# CITY OF ALBUQUERQUE

**Re: Chase Bank – Indian School Rd.  
6670 Indian School Rd NE  
Request for Certificate of Occupancy  
Transportation Development Final Inspection  
Engineer's/Architect's Stamp dated 7-12-21 (J18D001C)  
Certification dated 9-24-21**

TRAFFIC CIRCULATION PLAN

C1.02

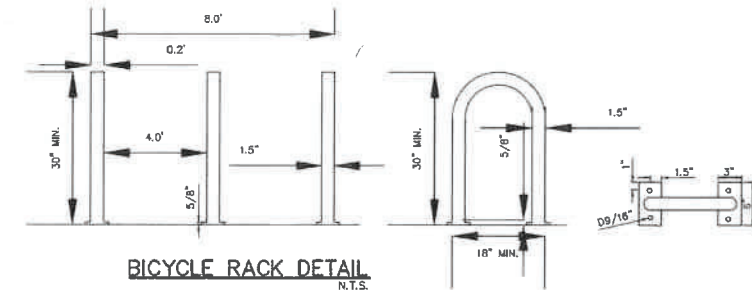
- Too much construction activity happening on site.
- Please complete items listed on Certification letter.
- Add Motorcycle signs.
- Install dumpster.
- Remove construction equipment and debris from site.
